UNITED STATES PATENT AND TRADEMARK OFFICE

10/537,481

Christopher Thomas Elsworthy

DETAILED ACTION

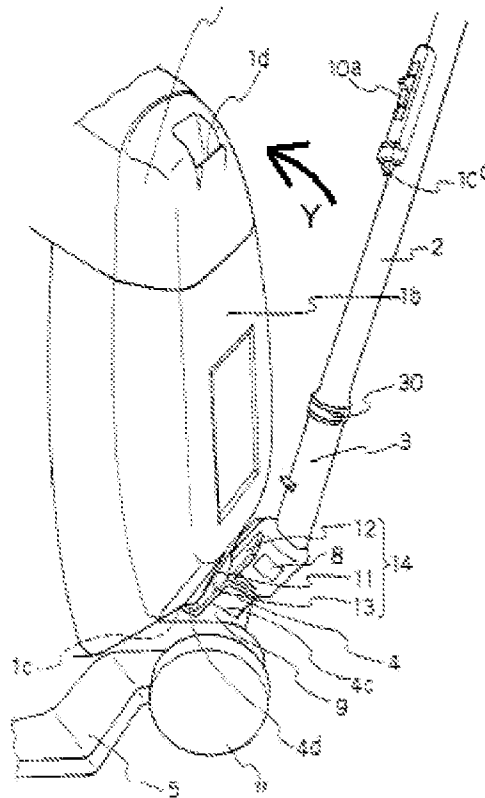
8. In reference to claim 1, Yoshimi discloses a suction cleaner of the cylinder type comprising a main unit (1) including a source of suction and a dust separating/collecting mechanism; a flexible hose (6), a wand (2) with a cleaning head (5) attached thereto; wherein the main unit is able to be stood on its end and there is releasable catch means (1c, 1d, 4d and 10) providing for the wand and cleaning head to be releasably connected to the main unit, wherein, when connected to the main unit, part of the wand lies at least partially within a recess provided in the main unit (parts 4d and 10 are both considered to be part of the wand, and are both positioned within respective recesses, 1c and 1d, which are part of the main body).

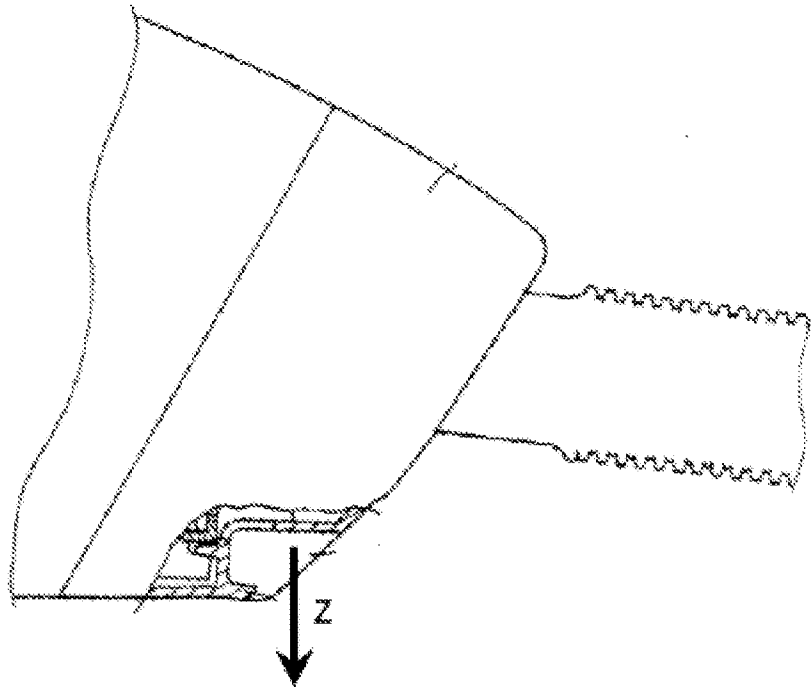
the direction of arrow Y below), which inherently includes a vector of movement upward relative to the main unit. Therefore, the second catch formations of Yoshimi are engagable by an upward movement of the wand, both immediately prior to (during placement of main unit on formation 4d) and during engagement (rotational motion having vector of movement upward) of the formation (10) on the wand with formation (1d) on the main unit.

12. In reference to claim 6, the second catch formation (1d) on the main unit is a recess that may be considered to be downwardly facing (as shown by arrow Z below) when the main unit is in the orientation to be used as a separate canister, wherein the lower surface 1b is positioned on or parallel to the ground (shown in Fig. 13), and the

wand comprises a complementary projection (10) that is engagable with the recess (1d).

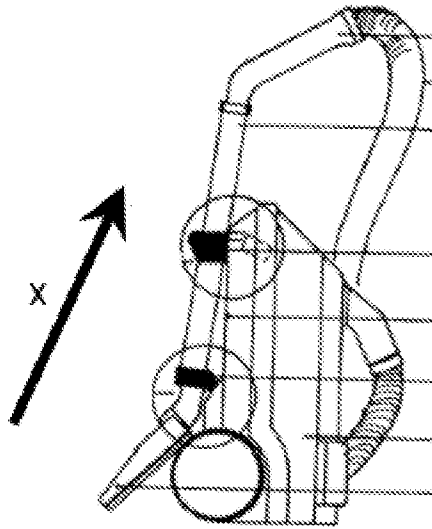
14. In reference to claim 1, Busalt discloses a suction cleaner of the cylinder type comprising a main unit (1) including a source of suction and a dust separating/collecting mechanism; a flexible hose (2), a wand (4) with a cleaning head (5) attached thereto; wherein the main unit is able to be stood on its end and there is releasable catch means (shown in Figures 2 and 3) providing for the wand and cleaning head to be releasably connected to the main unit, wherein, when connected to the main unit, part of the wand lies at least partially within a recess provided in the main unit (part 11, which is

considered to be a part of the wand, and a portion of the wand 4 are both positioned within respective recesses within catch means 7 and 8, which are part of the main body).

17. In reference to claim 5, the second catch formations (8 and the outer circumference of the wand, which is spaced away from the cleaning head) are inherently capable of being engagable by an upward movement of the wand relative to the main unit, having regard to the orientation of the main unit when it is stood on its end. In the orientation of the main body, shown in Fig. 1, the wand may be moved upwardly and toward the bottom of the main unit (in the general direction of arrow X, shown below) in order to engage the second catch formations.
